Re: Docket No. 20180231-EI; Petition for approval of the big bend south gypsum storage area closure project for cost recovery through the environmental cost recovery clause, by Tampa Electric Company

Attached for filing in the above docket is Tampa Electric Company's Responses to Staff's First Data Request (Nos. 1-17) dated January 18, 2019.

**TAMPA ELECTRIC COMPANY  
DOCKET NO. 20180231-EI  
STAFF'S FIRST DATA REQUEST  
REQUEST NO. 1  
PAGE 1 OF 9  
FILED: FEBRUARY 5, 2019**

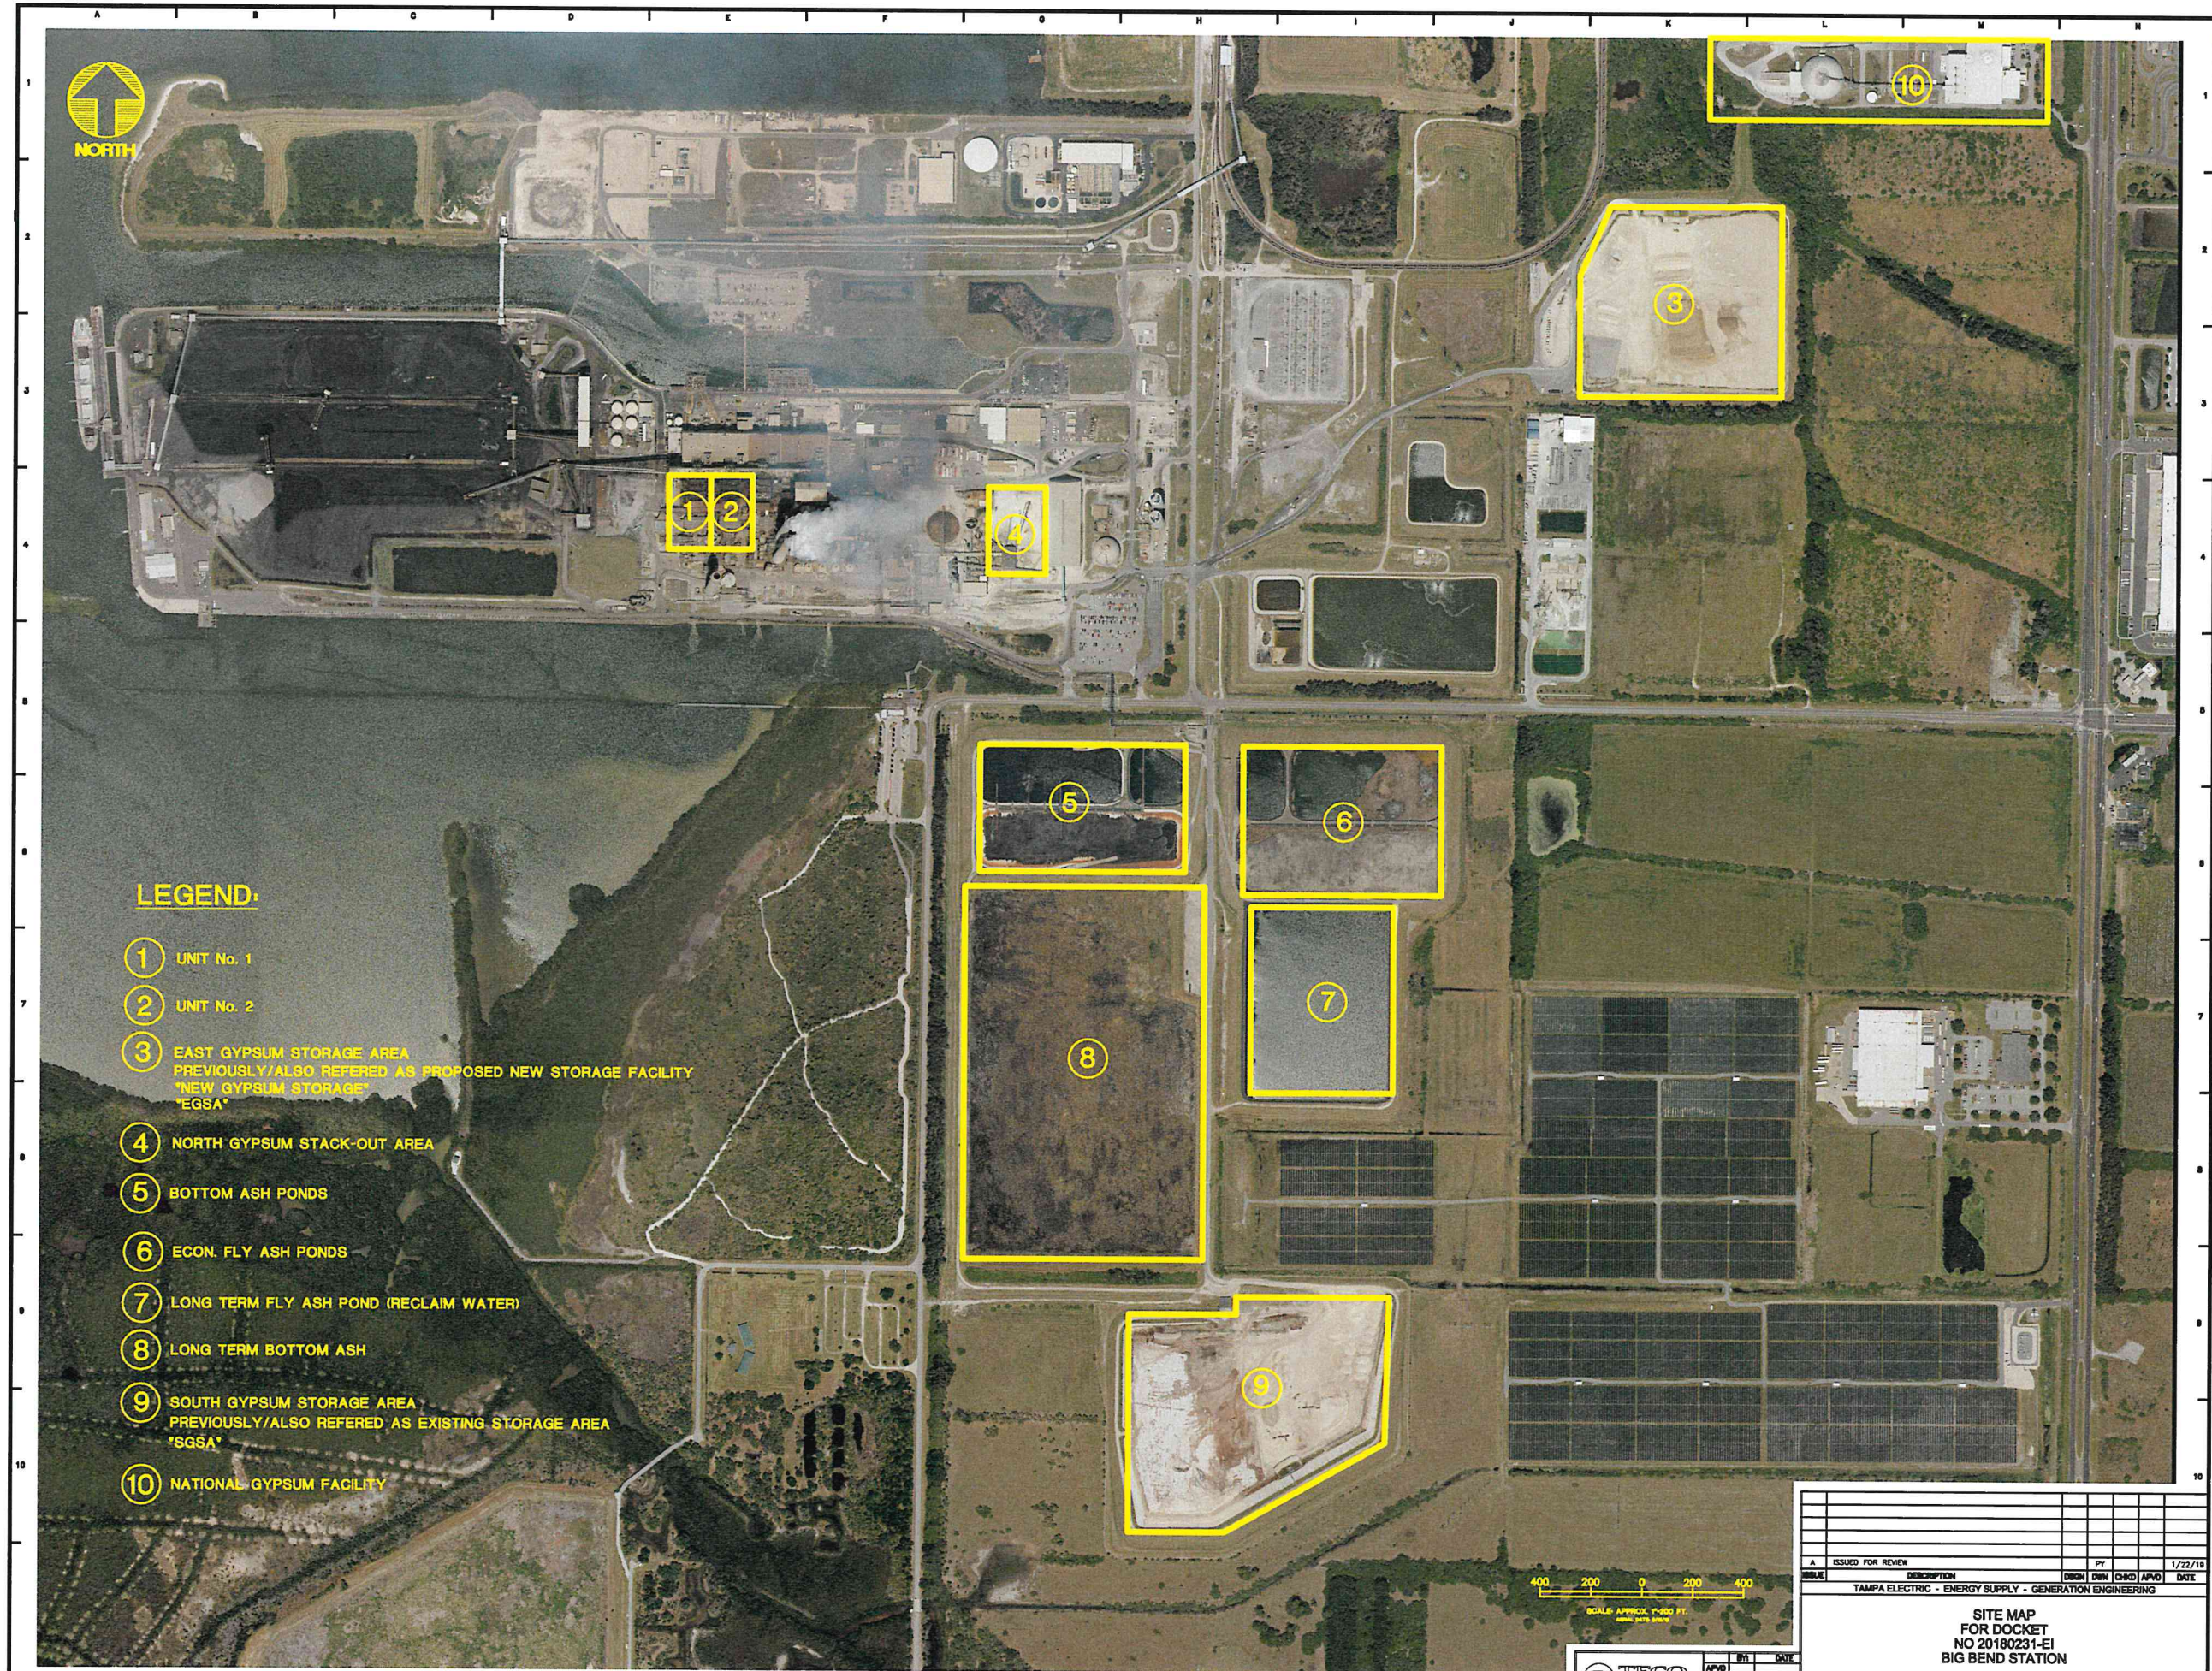
- 9.** Please provide a map or diagram to scale of the SGSA and the EGSA. Please include the two Gypsum storage areas and the Big Bend Units 1&2 in one diagram.

- iv. **TECO’s instant Petition**
17. Please provide a drawing to show all the gypsum and coal ash storage facilities (ponds, storage area, etc.) at the Big Bend Station. Please also clearly mark out the locations of the following:

- a. The “Existing Storage Facility” and “Proposed New Storage Facility” described in document (i) (pages 11 and 12).
  - b. The New Gypsum Storage approved in document (ii).

- c. The North Gypsum Stack out area discussed in document (iii).
  - d. SGSA and EGSA discussed in document (iv).
- A. See the site map provided in Staff’s First Data Request, No. 9.

- A.** The attached site map provides a scale diagram of the SGSA and the EGSA and shows Big Bend Units 1 and 2.
